**APPLICATION OF 1728
14TH STREET LLC**

**BZA APPLICATION NO. 18453
HEARING DATE: JUNE 25, 2013
ANC 2F**

**MEMORANDUM OF POINTS AND AUTHORITIES IN SUPPORT OF
REQUEST FOR MODIFICATION PER 11 DCMR,
SECTIONS 3129.7 AND 3129.8**

PROPOSED CELLAR FLOOR PLAN

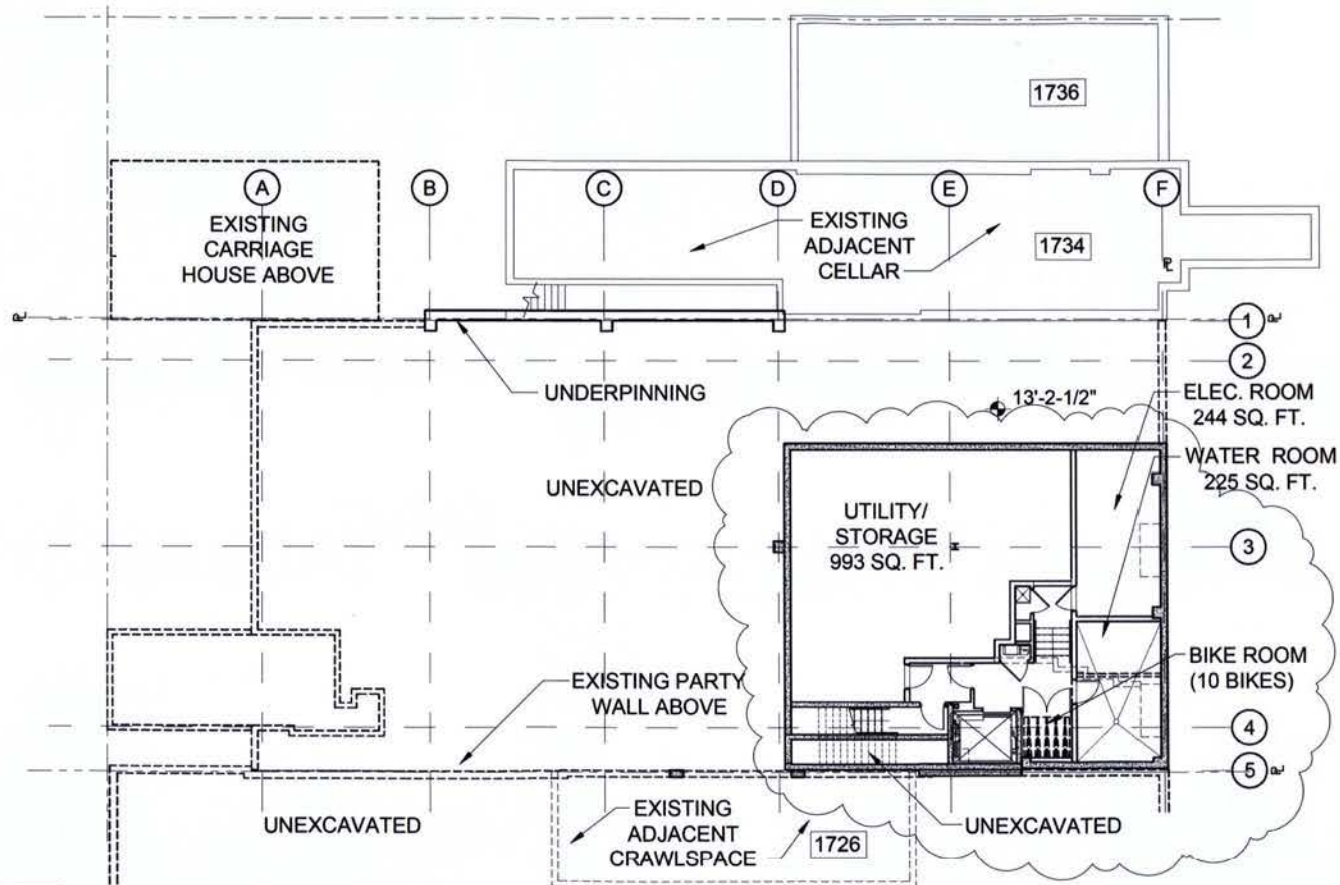
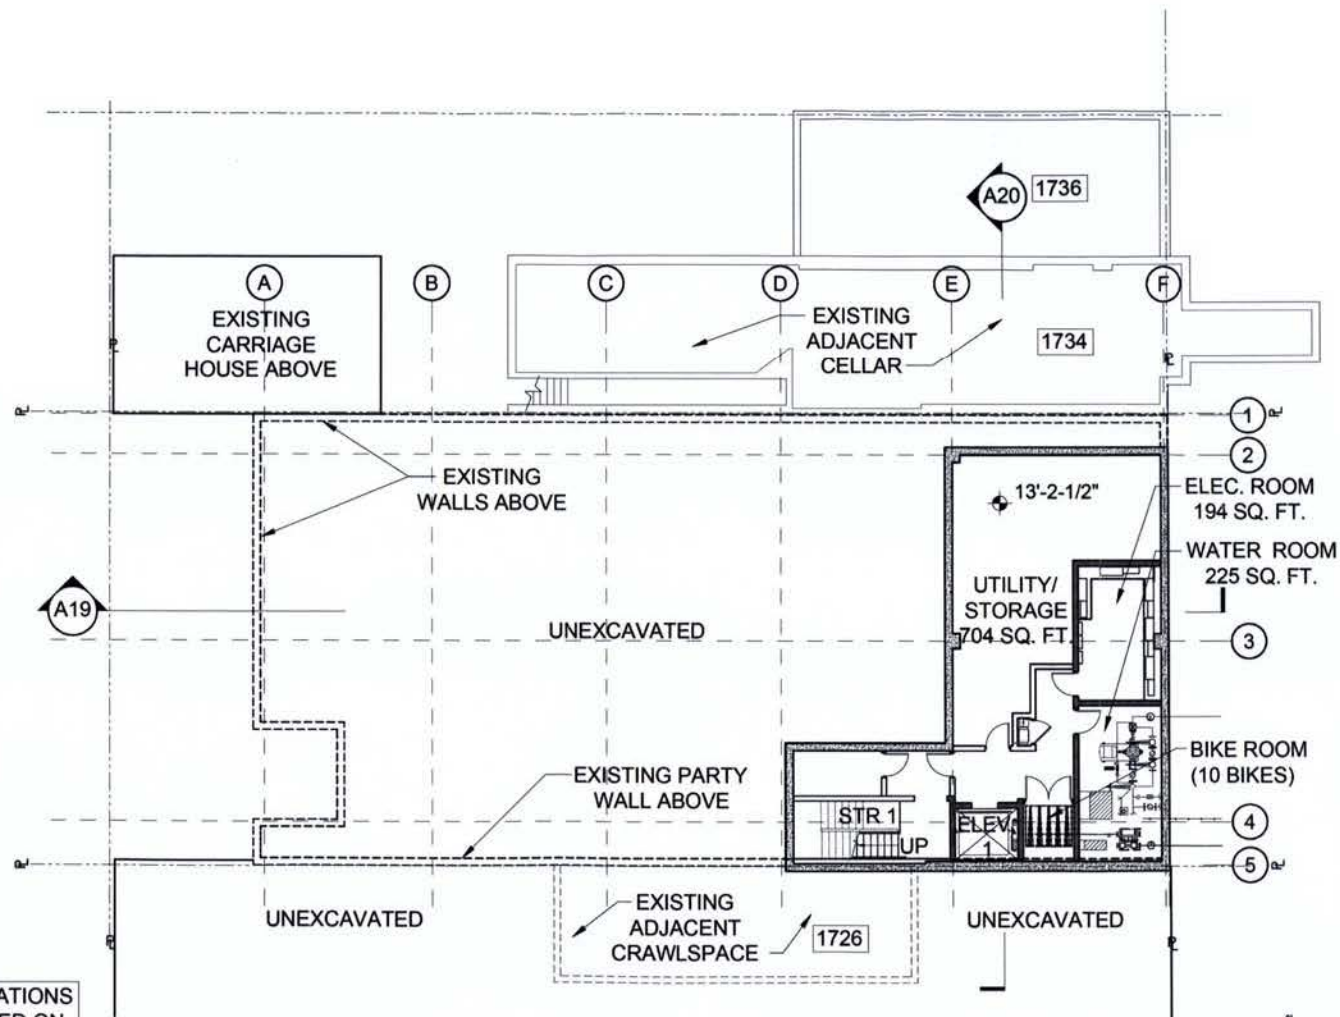
The owner wishes to modify the configuration of the cellar level. The modification will change the cellar configuration from an "L-shape" to a rectangular shape. This modified shape is dictated by the structural needs of the project, which require that the cellar excavation be set back an adequate distance from the building to the north. After the BZA Order was issued, the structural engineer advised the Applicant that the location of the north wall of the cellar in the original plans was too close to the south wall of the adjacent building to the north to ensure the integrity of that building, which is a fragile historic structure. In addition, the stairway configuration to the cellar has been reversed, in order to minimize the amount of excavation along the property line adjacent to the historic structure to the south. As shown on the plans, the

cellar reconfiguration corresponds to the locations of the grid structure. This reconfiguration slightly increases the size of the cellar by 108 sq ft (from 1992 sq ft to 2100 sq ft).
